SUBJECT: Transmittal of Revised Responses to AP1000 DSER Open Items

AP1000 Design Certification Review
Draft Safety Evaluation Report Open Item Non-Proprietary Responses

DSER Open Item Number: 3.6.3.4-2 Addendum 1 Revision 2

Figure 15 - Bounding Analysis Curve – DVI-A – 8" PXS

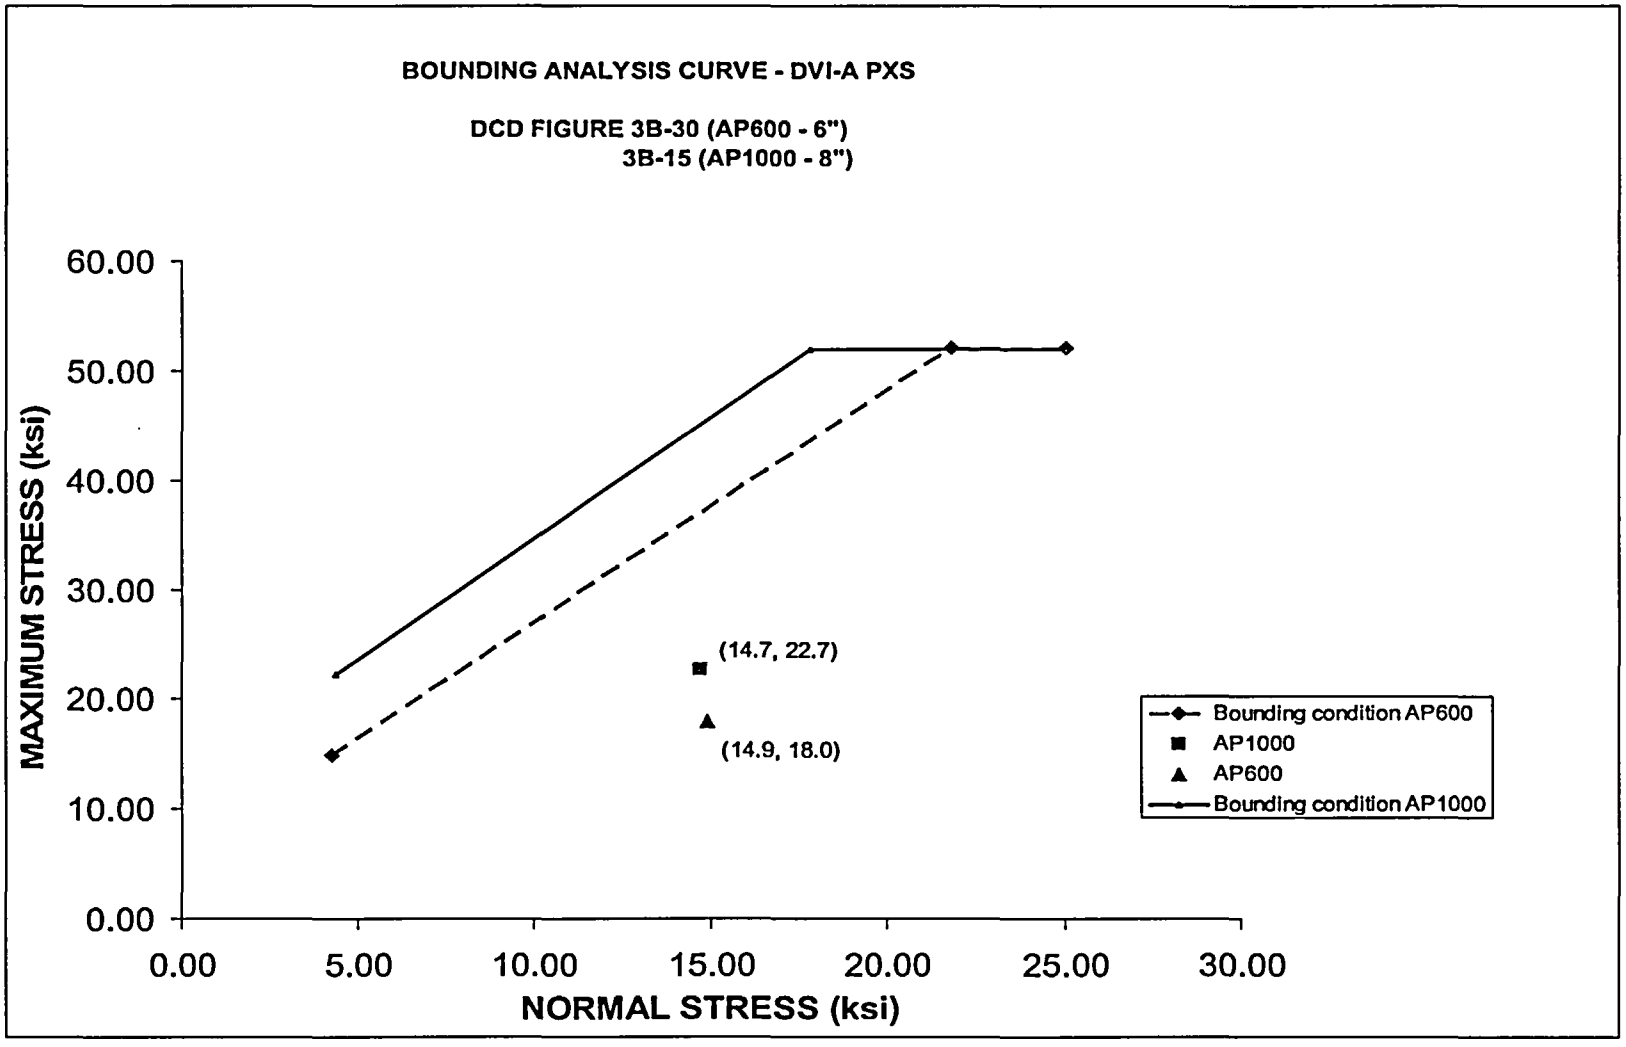
Revision 2 of this response provides discussion and results of revised DVI-A piping analysis in Section 2.5 and Figures 10-15 of this addendum.

Pipe Segment	Maximum Calculated Stress (ksi)	Bounding Analysis Curve Limit (ksi)	Report Figure
8-inch, 316SS, 537F	26.5~~23.9~~	41.6	Fig. 10
8-inch, 316SS, 120F	25.8~~22.0~~	51.9~~44.0~~	Fig. 11
8-inch, 304	14.8~~13.8~~	16.2~~14.4~~	Fig. 12
8-inch, Sch 40S	14.6~~11.7~~	22.7	Fig. 13
6-inch, RNS	14.6~~14.5~~	26.1~~22.9~~	Fig. 14
8-inch, PXS	26.5~~22.3~~	45.4~~44.5~~	Fig. 15

Figure 38 : Bounding Seismic Increase Factors -
Seismic Response Spectra, Steam Generator Support Elev. 135', (North-South) – 4th Stage ADS

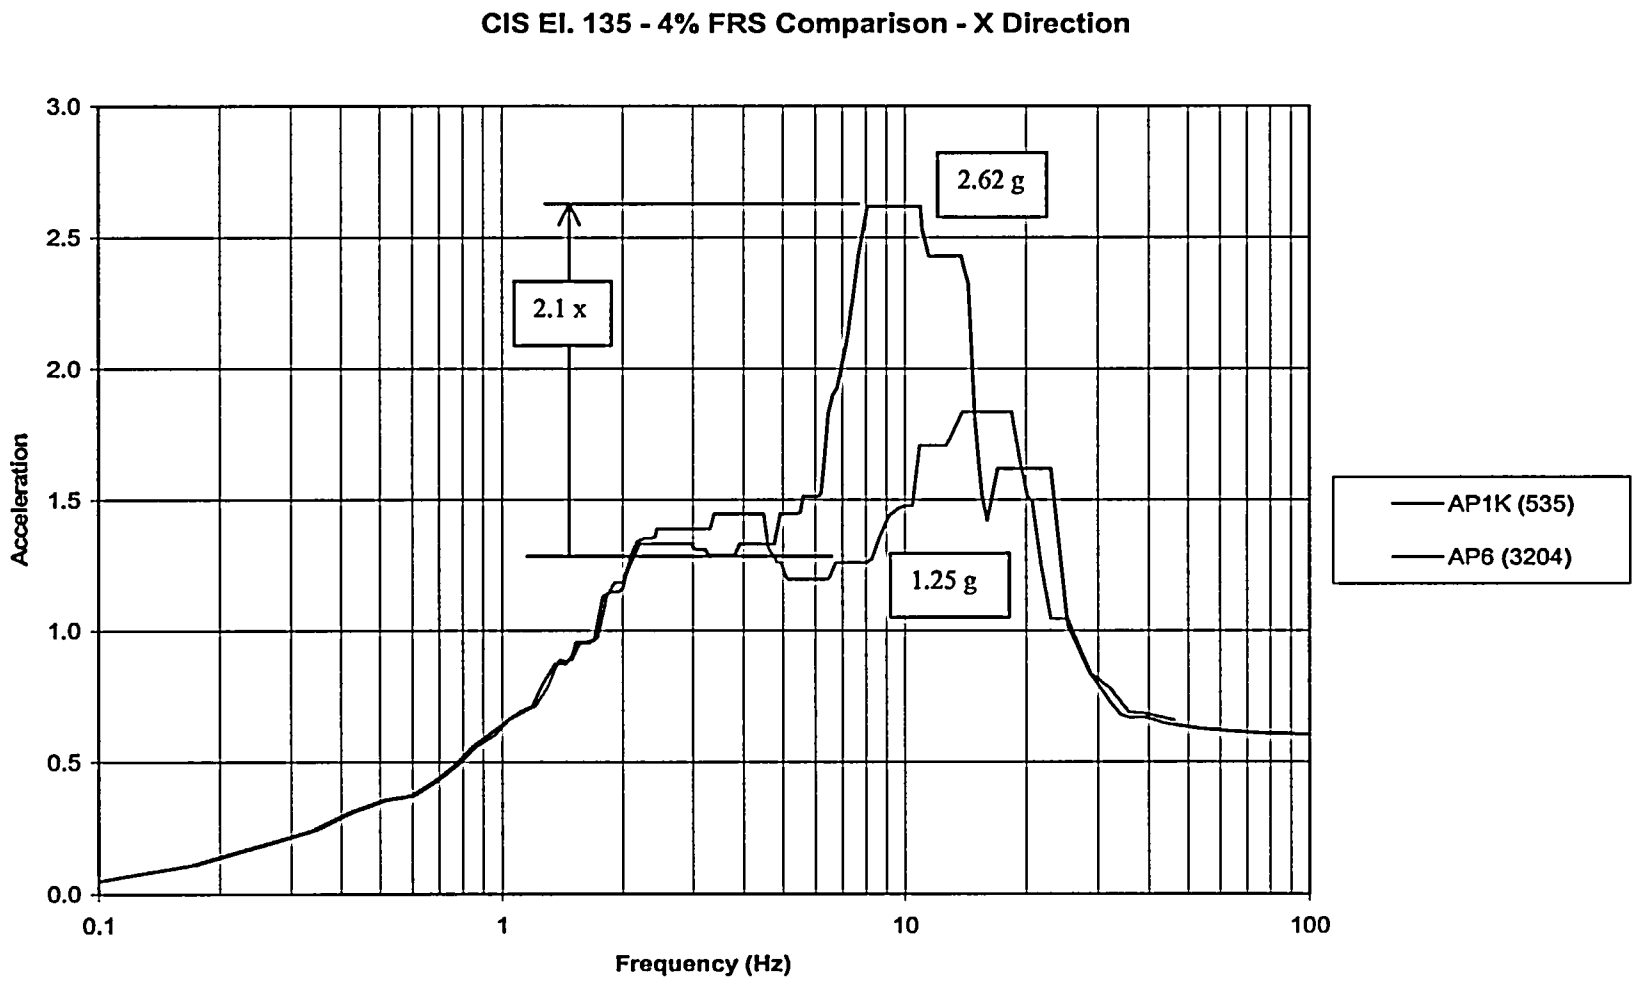
The ADS Stage 4 pipe diameter is larger than the AP600 (12"). Per Figure 38, the seismic increase factor is 2.1 based on the seismic response spectra at approximately 8 Hz. The maximum stress is 33.0 ksi accounting for both the seismic increase factor and the increase in pipe diameter. The adjusted stress is less than the BAC stress of 40.7 ksi. Figure 40 shows the BAC and the estimated stresses for the AP1000 plant. Feasibility of LBB for AP1000 is confirmed.

The ADS Stage 4 pipe diameter is larger than the AP600 (10"). Per Figure 38, the seismic increase factor is 2.1 based on the seismic response spectra at approximately 8 Hz. The maximum stress is 38.0 ksi accounting for both the seismic increase factor and the increase in pipe diameter. The adjusted stress is less than the BAC stress of 40.7 ksi. Figure 41 shows the BAC and the estimated stresses for the AP1000 plant. Feasibility of LBB for AP1000 is confirmed.

The ADS Stage 4 pipe diameter is larger than the AP600 (10"). Per Figure 38, the seismic increase factor is 2.1 based on the seismic response spectra at approximately 8 Hz. The maximum stress is 36.5 ksi accounting for both the seismic increase factor and the increase in pipe diameter. The adjusted stress is less than the BAC stress of 51.9 ksi. Figure 42 shows the BAC and the estimated stresses for the AP1000 plant. Feasibility of LBB for AP1000 is confirmed.

Figure 39 : Bounding Seismic Increase Factors
Seismic Response Spectra, Steam Generator Support Elev. 153' (East-West) – 4th Stage ADS

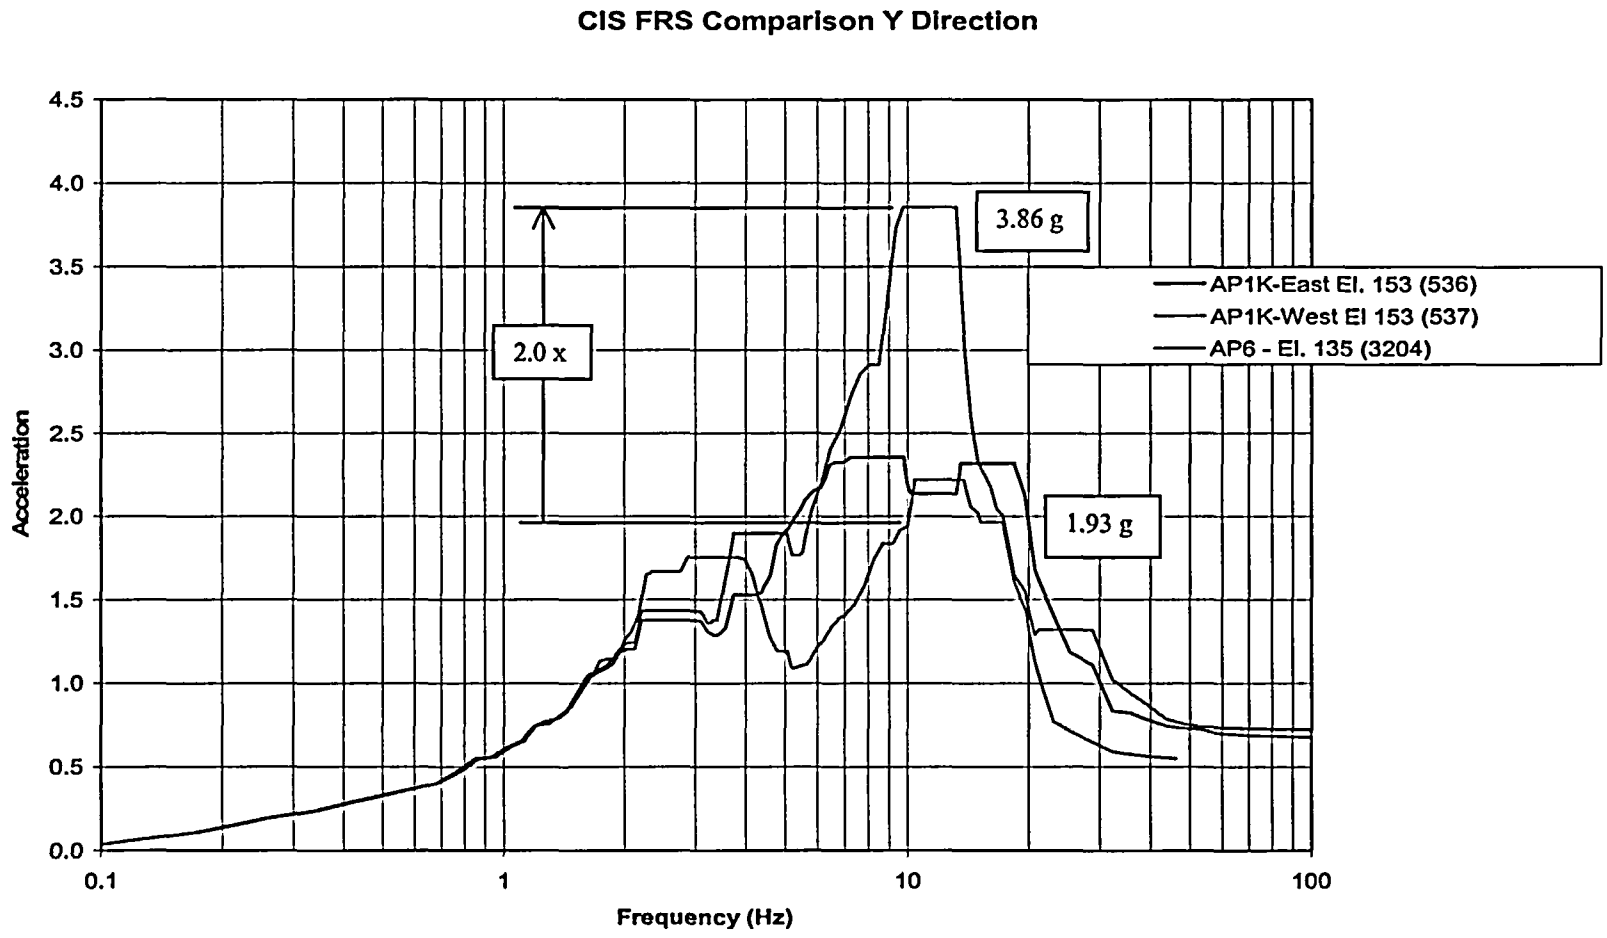
The ADS Stage 4 pipe diameter is larger than the AP600 (12"). Per Figure 39, the seismic increase factor is 2.0 based on the seismic response spectra at approximately 10 Hz. The maximum stress is 23.7 ksi accounting for both the seismic increase factor and the increase in pipe diameter. The adjusted stress is less than the BAC stress of 40.7 ksi. Figure 40 shows the BAC and the estimated stresses for the AP1000 plant. Feasibility of LBB for AP1000 is confirmed.

The ADS Stage 4 pipe diameter is larger than the AP600 (10"). Per Figure 39, the seismic increase factor is 2.0 based on the seismic response spectra at approximately 10 Hz. The maximum stress is 30.0 ksi accounting for both the seismic increase factor and the increase in pipe diameter. The adjusted stress is less than the BAC stress of 31.6 ksi. Figure 41 shows the BAC and the estimated stresses for the AP1000 plant. Feasibility of LBB for AP1000 is confirmed.

The ADS Stage 4 pipe diameter is larger than the AP600 (10"). Per Figure 39, the seismic increase factor is 2.0 based on the seismic response spectra at approximately 10 Hz. The maximum stress is 26.4 ksi accounting for both the seismic increase factor and the increase in pipe diameter. The adjusted stress is less than the BAC stress of 51.9 ksi. Figure 41 shows the BAC and the estimated stresses for the AP1000 plant. Feasibility of LBB for AP1000 is confirmed.

Figure 5.3-2

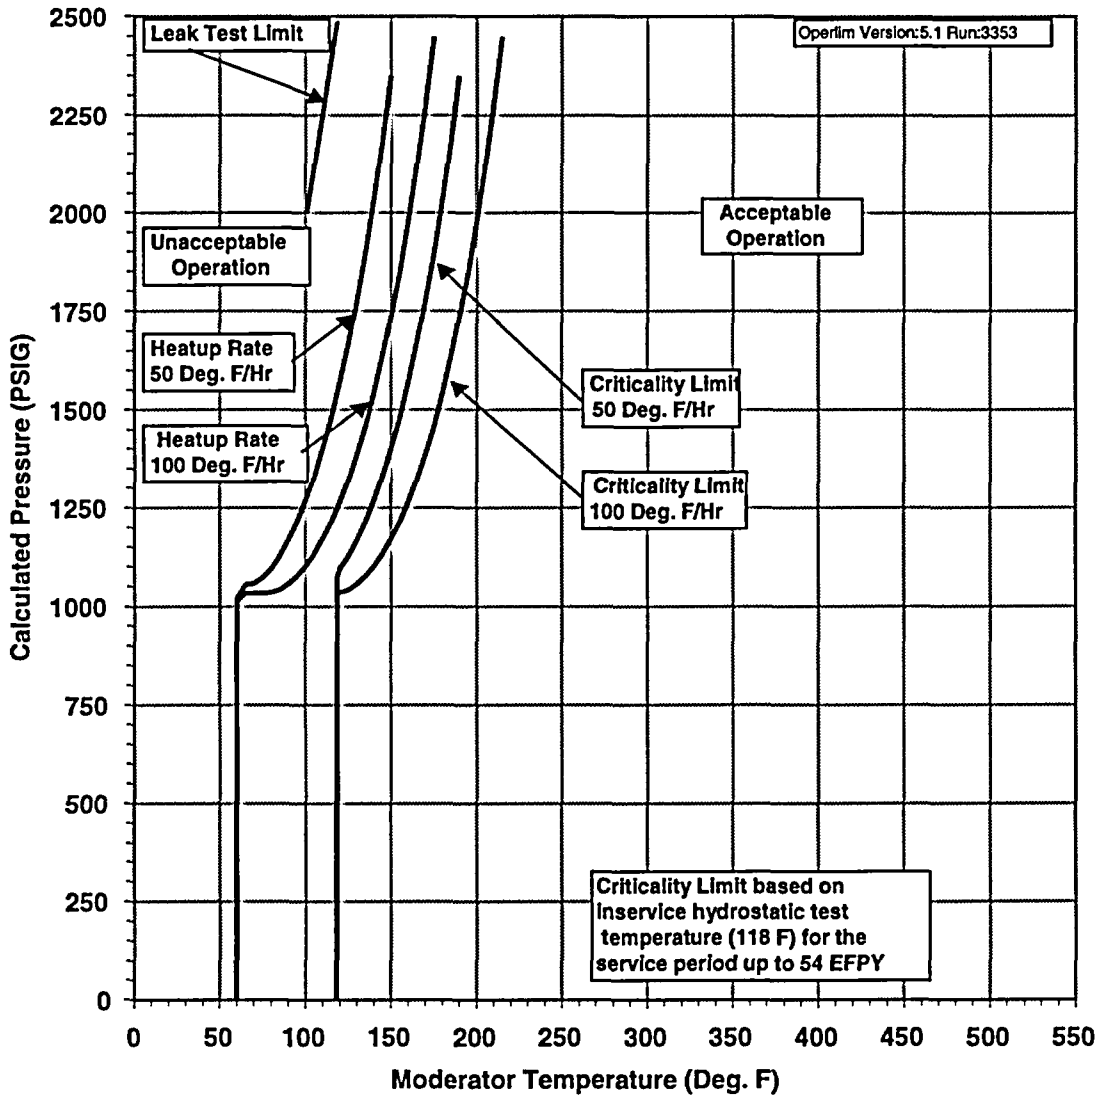
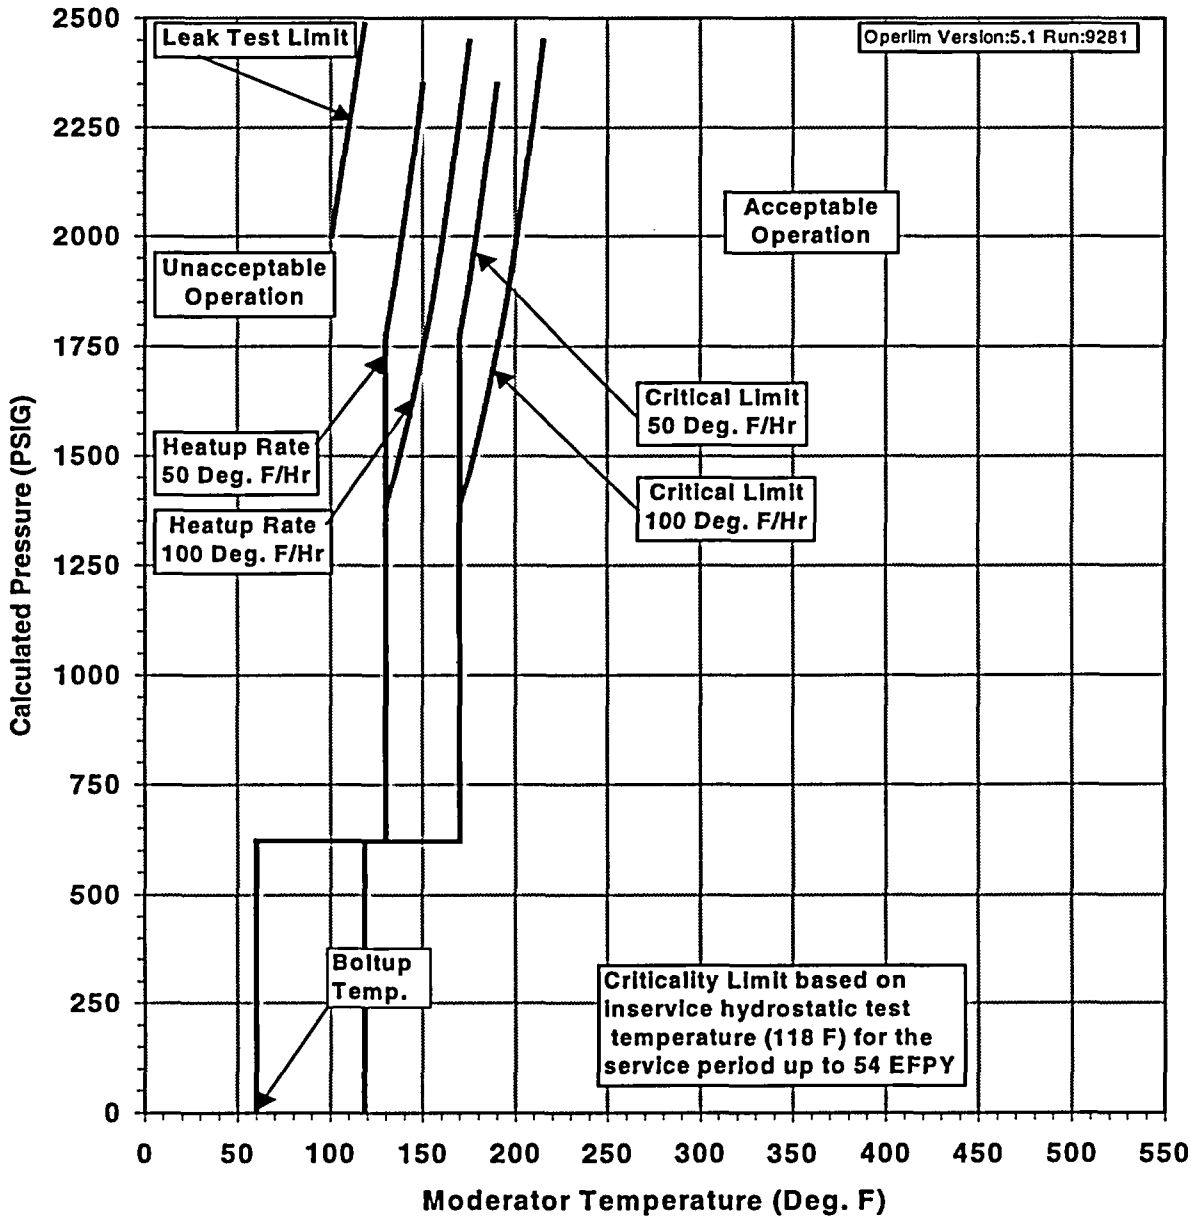
Current Figure 5.3-2

Revised Figure 5.3-2

Figure 5.3-3

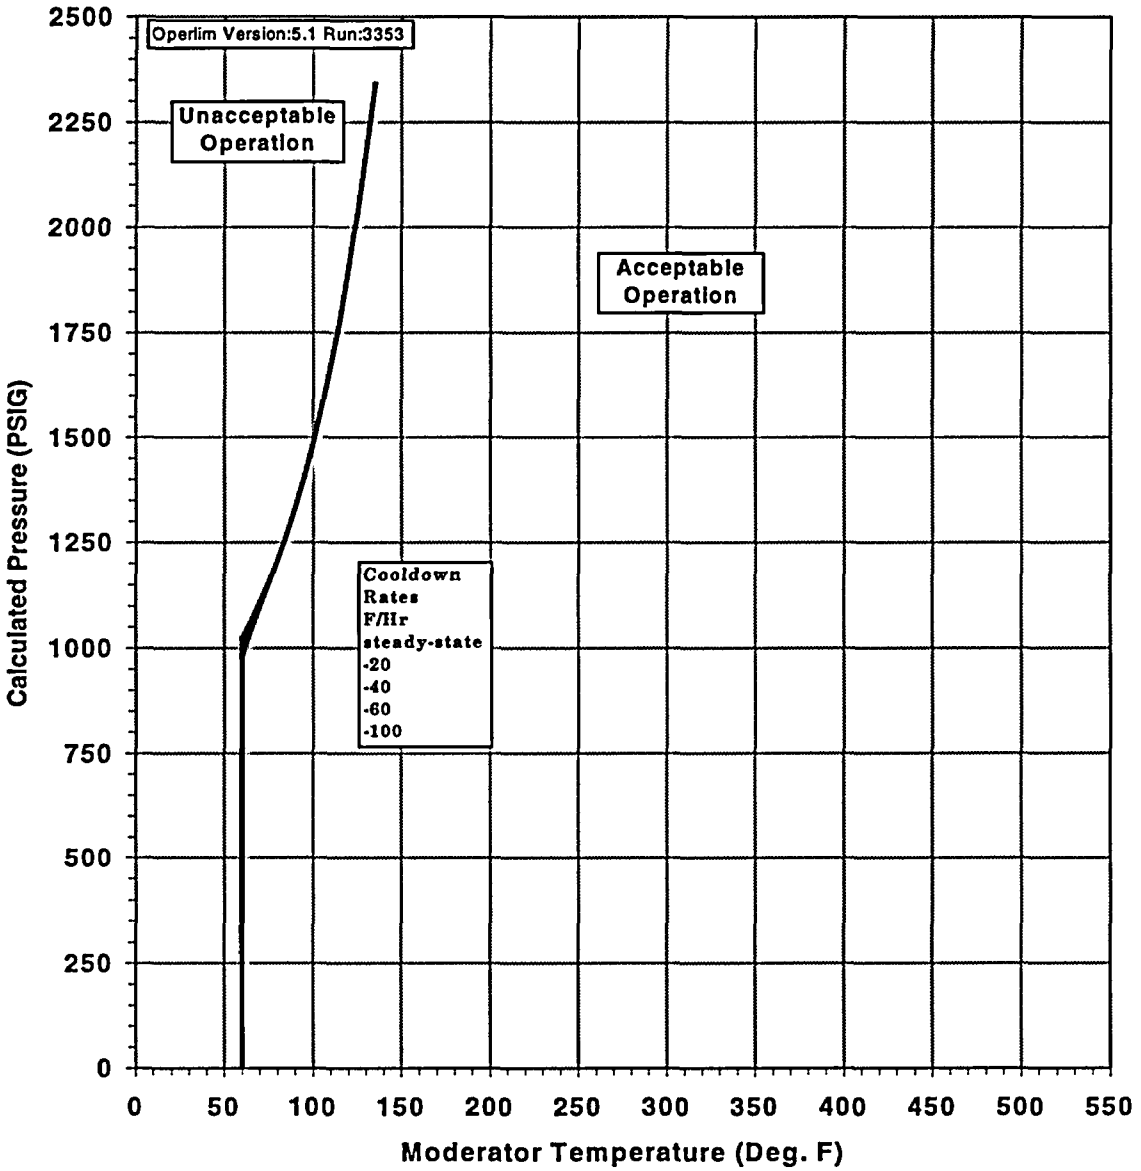
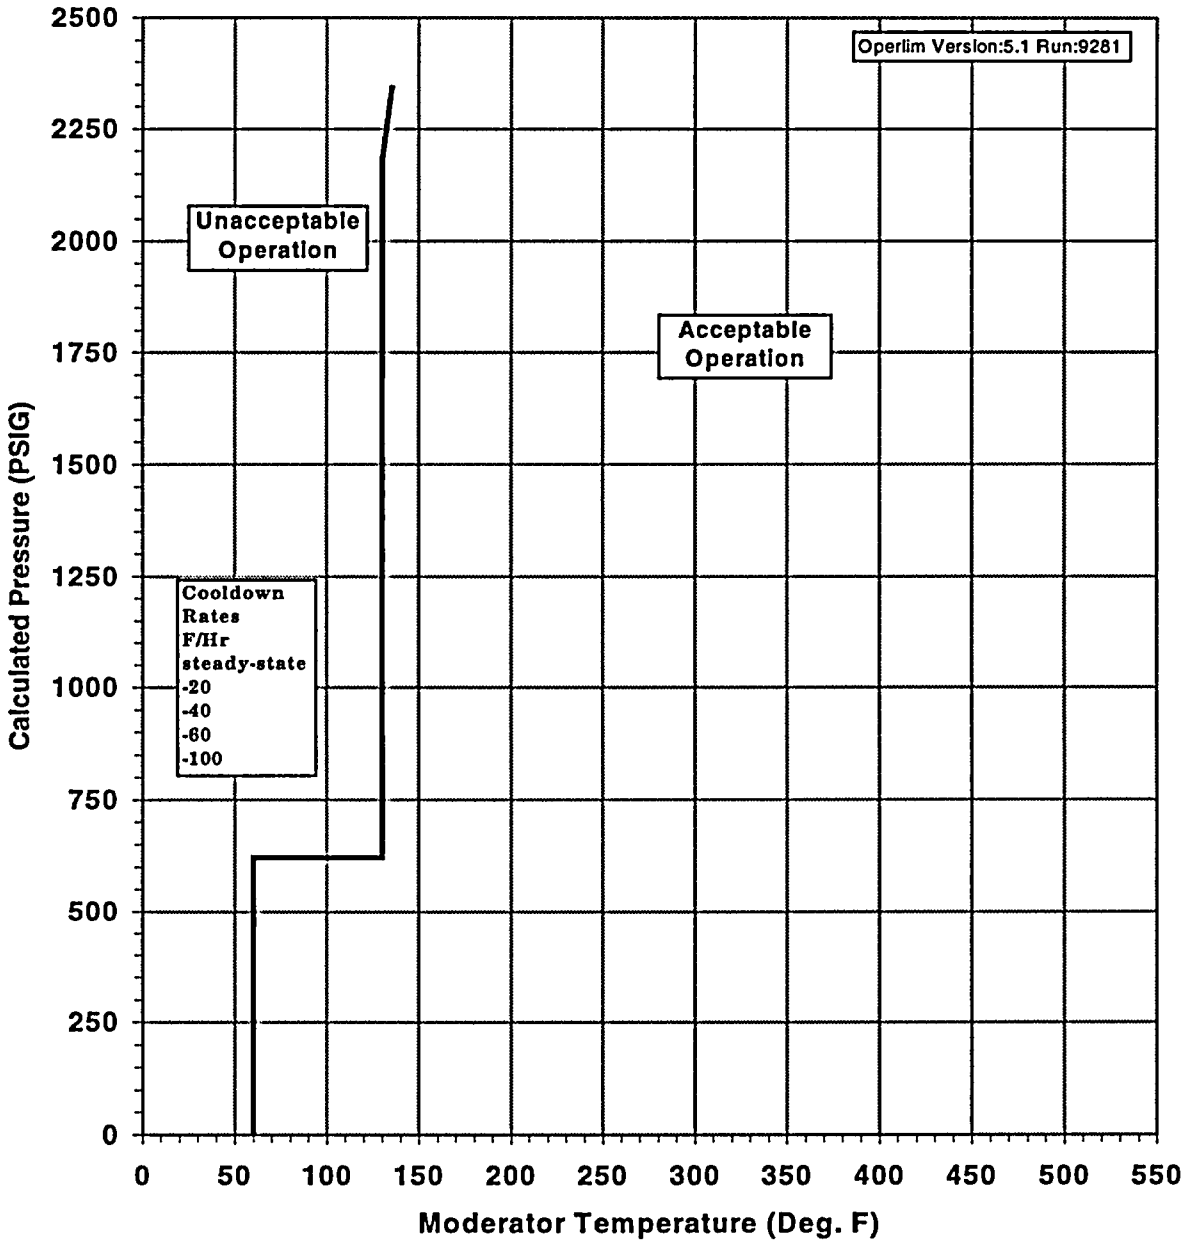
Current Figure 5.3-3

Revised Figure 5.3-3
